## **Objection Letter**

**Application Number 2016/4372/P**

Site Address 11-12 Grenville Street London WC1N 1LZ

**Proposal** Change of use of ground floor (part) and upper stores from office (B1) to residential (C3) and consolidate existing ground floor retail (A1) and cafe (A3) units to a new A1/A3 commercial unit and converting rear garage to self-contained C3 unit together with new mansard roof extension and associated internal alterations (proposed).

1: View from the rear

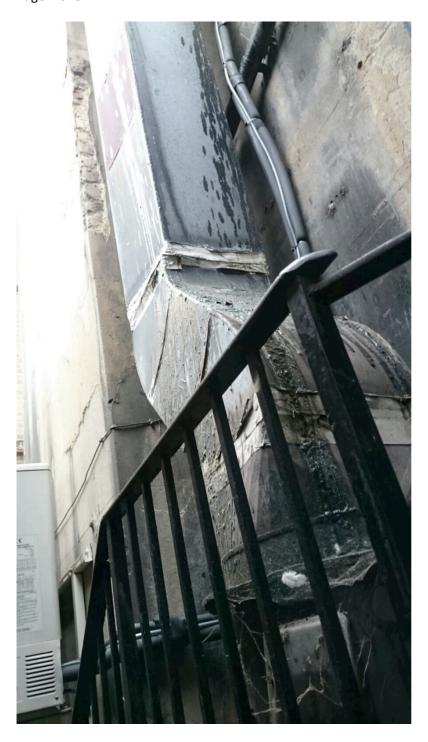
I have made searches on submitted details and documents with my architect and submitted documents do not represent existing extractor system and flue to the rear (images below)

We have strong concern that the existing Extractor and Flue has not been taken into account and we believe this will create major issues of noise and odour with future occupiers of upper floor in case the recent application gets approved therefore we seek this application to get refused and new application with relevant reports from environmental engineers in accordance with existing installed system and proposal for quality life standards within residential location

Based on luck of information we object to current application and seek clear statement from Environmental Engineers to be approved by Camden Council Environmental Department re Existing Extractor System & Flue
